3GPP TSG CN Plenary Meeting #17
4th – 6th September 2002 Biarritz, FRANCE.

NP-020444

Source: TSG CN WG4
Title: TrFO/Codec control
Agenda item: 7.7
Document for: APPROVAL

Title:	⌘ Initial Bitrate For TrFO		
Source:	⌘ CN4		
Work item code:	⌘ OoBTC	Date:	⌘ 03/07/02
Category:	⌘ F	Release:	⌘ REL-4
	Use <u>one</u> of the following categories: F (correction) A (corresponds to a correction in an earlier release) B (addition of feature), C (functional modification of feature) D (editorial modification) Detailed explanations of the above categories can be found in 3GPP TR 21.900.		Use <u>one</u> of the following releases: 2 (GSM Phase 2) R96 (Release 1996) R97 (Release 1997) R98 (Release 1998) R99 (Release 1999) Rel-4 (Release 4) Rel-5 (Release 5) Rel-6 (Release 6)

Figure 5.4.3/1:RFCI Value Correction

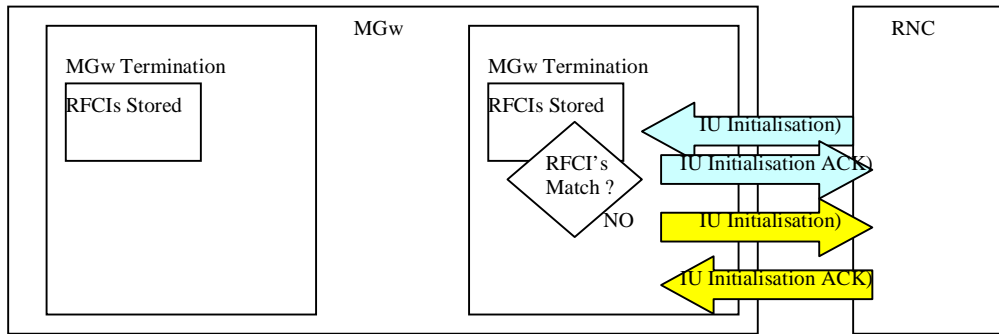
Reason for change:	⌘ Initial bitrate/first rate control is not handled/described. Some changes have been made in RAN3 specification (25.415) to describe the initial bitrate definition within the luUP protocol. The handling of this is missing from 23.153
	This CR is category F – essential correction.
Summary of change:	⌘ Initial bitrate is received during the Initialisation and shall be noted by each MGW. At call establishment the terminating MGW shall handle the initial bitrate and be treated as an initial rate control. The MGW shall send a rate control PDU if the initialisation frame is not being transferred to the next node.
Consequences if not approved:	⌘ Nodes and RAN may not be using the same initial mode at call establishment.

- 1) initiate an Iu Framing Initialisation PDU towards the terminating RNC with the RFCI allocation as defined by the preceding node (previously stored in the MGW. This behavior is shown in figure 5.4.3/1 and termed "RFCI value correction"). As the first Subflow combination received from the terminating RNC corresponds to an initial (maximum) rate control the MGW shall send a Rate Control PDU indicating this maximum speech mode back to the preceding node in the core-network.~~or~~

- 2) map the RFCI indices of the incoming side to the corresponding RFCI indices at the outgoing side for all SDUs passed between the Iu Framing protocol terminations. As the first Subflow combination in the IuUP initialisation corresponds to an indicates the initial rate control, i.e. indicates maximum rate for the mode to be used (in direction of Initialisation acknowledgement frame) it is and therefore the treated as the initial maximum rate control (see [4]) the MGW shall initiate a Rate Control PDU indicating this maximum speech mode toward the terminating RNC and toward the preceding core network node. Similarly as the first Subflow combination received from the terminating RNC corresponds to an initial (maximum) rate control the MGW shall send a Rate Control PDU indicating this maximum speech mode back to the preceding node in the core-network. For further details on the rate control see clause 5.7

Figure 5.4.3/1:RFCI Value Correction

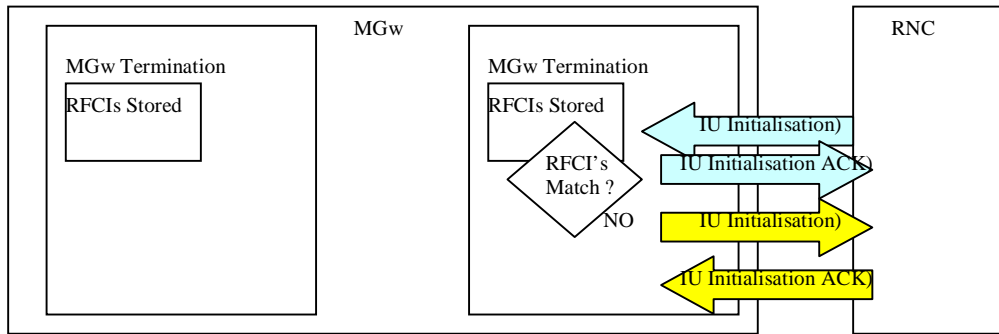
Reason for change:	⌘	Initial bitrate/first rate control is not handled/described. Some changes have been made in RAN3 specification (25.415) to describe the initial bitrate definition within the luUP protocol. The handling of this is missing from 23.153
		This CR is category F – essential correction. This is mapped from REL4.
Summary of change:	⌘	Initial bitrate is received during the Initialisation and shall be noted by each MGW. At call establishment the terminating MGW shall handle the initial bitrate and be treated as an initial rate control. The MGW shall send a rate control PDU if the initialisation frame is not being transferred to the next node.
Consequences if not approved:	⌘	Nodes and RAN may not be using the same initial mode at call establishment.

- 1) initiate an Iu Framing Initialisation PDU towards the terminating RNC with the RFCI allocation as defined by the preceding node (previously stored in the MGW. This behavior is shown in figure 5.4.3/1 and termed "RFCI value correction"). As the first Subflow combination received from the terminating RNC corresponds to an initial (maximum) rate control the MGW shall send a Rate Control PDU indicating this maximum speech mode back to the preceding node in the core-network.~~or~~

- 2) map the RFCI indices of the incoming side to the corresponding RFCI indices at the outgoing side for all SDUs passed between the Iu Framing protocol terminations. As the first Subflow combination in the IuUP initialisation corresponds to an ~~indicates~~ the initial rate control, i.e. indicates maximum rate for the mode to be used (in direction of Initialisation acknowledgement frame) it is ~~and therefore~~ treated as the initial maximum rate control (see [4]) the MGW shall initiate a Rate Control PDU indicating this maximum speech mode toward the terminating RNC ~~and toward the preceding core network node~~. Similarly as the first Subflow combination received from the terminating RNC corresponds to an initial (maximum) rate control the MGW shall send a Rate Control PDU indicating this maximum speech mode back to the preceding node in the core-network. For further details on the rate control see clause 5.7
